CAMECO RESOURCES

**January 2012 Excursion Report Summary Update and Response to LQD Comments on
November 2012 Excursion Report Summary Update, Cameco Resources, Smith Ranch-
Highland Uranium Project, Permit 603 and 633**

RESPONSE TO REVIEW OF NOVEMBER 2012 MONTHLY EXCURSION SUMMARY CAMECO RESOURCES

Water Level Trending Analysis

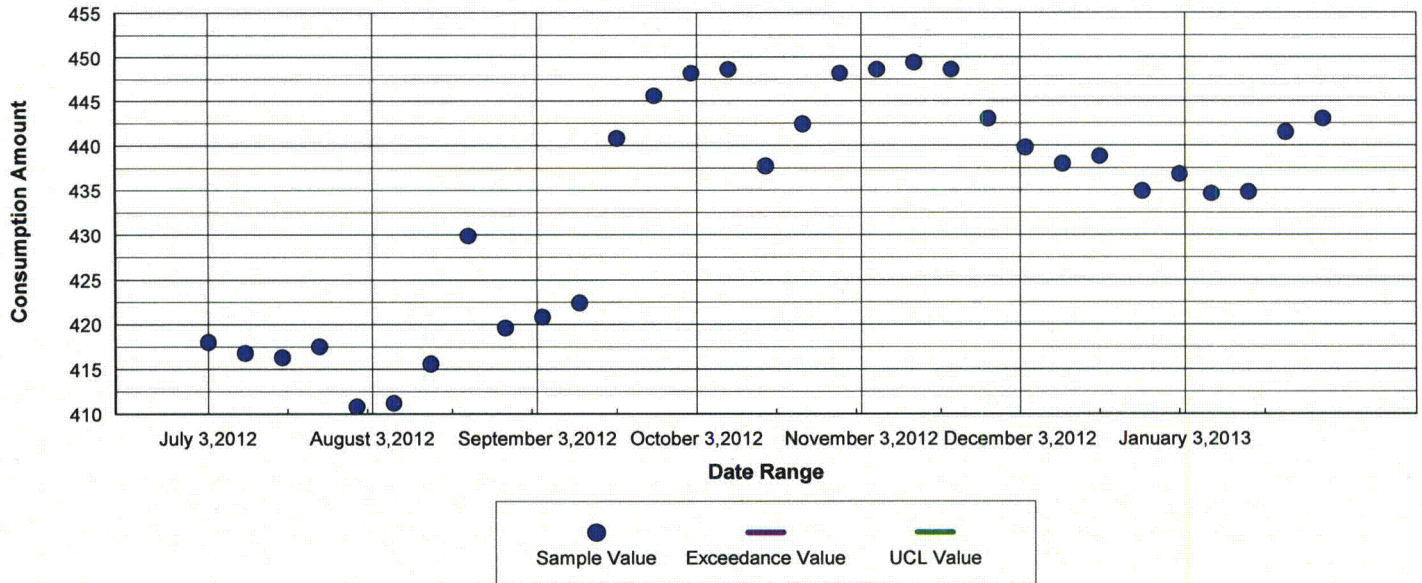
1. *It is recommended that the water level in Well DM-003 be compared with the water levels in surrounding wells to determine the water source. It appears that there may be mixing of native water with water of lesser quality. (SI)*

Cameco Response: Water levels in DM-003 and surrounding wells are taken monthly and evaluated as part of the excursion control efforts at DM-003. Cameco will be scheduling a meeting with LQD to discuss this excursion for some time in February.

Water Level
Trending Analysis
Well : FM-009

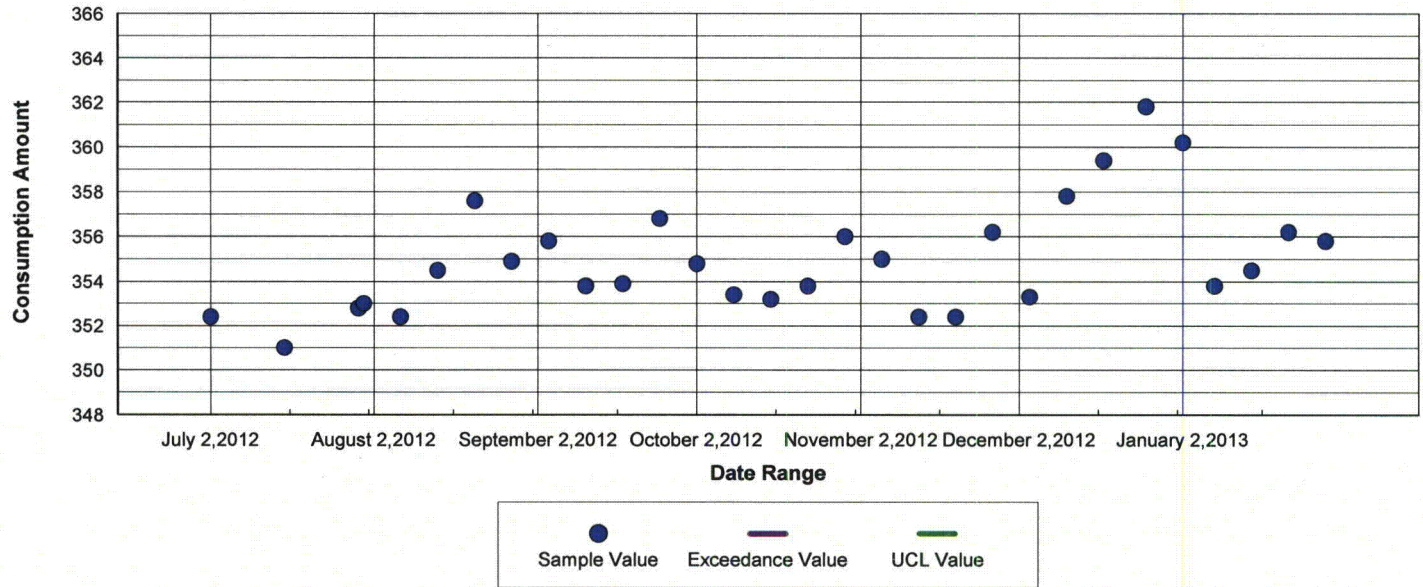
2. *The water level graph for Well FM-009 lists the water levels as "Consumption Amount". The graph appears to represent some form of depth to water, the water level changes do reflect the water level changes in data sheet for the well, but the numbers on the y-axis don't appear to correlate with anything. Please correctly identify the y-axis on the graph. (SI)*

Cameco Response: These trend graphs are produced through Cameco's SAP-based environmental database which houses all sample results for monitor wells. These graphs are a simple extract of data from two database fields, consumption amount and date, and cannot be altered based on the current structure of the SAP database. Because water level is put into the system as a depth to water surface, the trend graph would reflect that as the consumption value. The monitor well report data sheets that are produced through the system have a built in calculation that converts depth to water surface into water level elevation. Cameco recognizes the difference between the graph and data sheet; because Cameco is providing the water level trend graphs as a courtesy to LQD. If the inconsistency is problematic and creates confusion, Cameco will no longer provide the graphs and return to providing only the monitor well data sheets.
